Damage to vacuum pumps through incorrect assignment

Vehicle	Product: Vacuum pump	
	PIERBURG No.	O.E. No.*
VW Transporter LT, T4 (pickup, window van, panel van, California) Engine code: AAB	7.22300.62.0	075 145 100 ; 075 145 101; 075 145 101 A
	7.22300.69.0	074 145 100 A

Due to a change of the cylinder head in the case of the VW T4 engine with engine code AAB the vacuum pump has frequently been incorrectly assigned.

Fig. 3: Position of the camshaft during installation

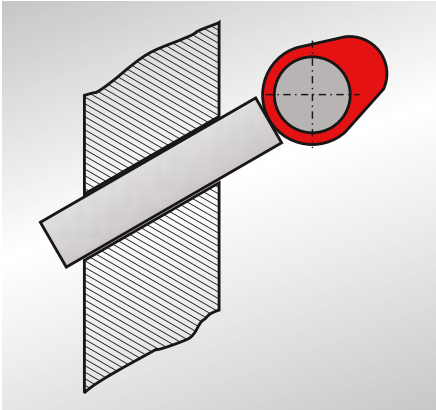
During installation work the cam of the camshaft which drives the vacuum pump must be located at the opposite side of the intermediate tappet rod (see Fig. 3) so as to be able to install the pump under a slight pre-tension only (gap of 2 mm max.):

Fig. 5: In the case of a wrong assignment, proper installation will not be possible

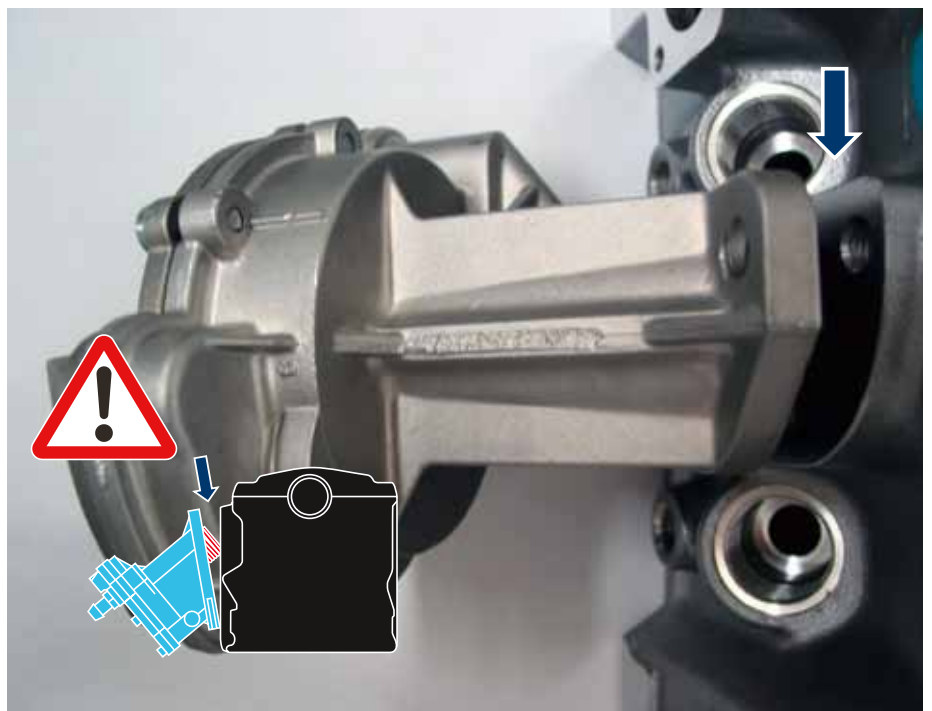
If the vacuum pump cannot be pressed onto the flange without exerting a significant amount of force (gap 5 mm approx.) although the cam is located at the opposite side of the intermediate tappet rod you can be sure that the assignment is wrong.

- !** Under all circumstances check
- vehicle identification number
 - registration date and/or
 - part number of the old pump!

- !** Never try to resolve this problem by modifying the intermediate
- tappet rod (by grinding, for example)
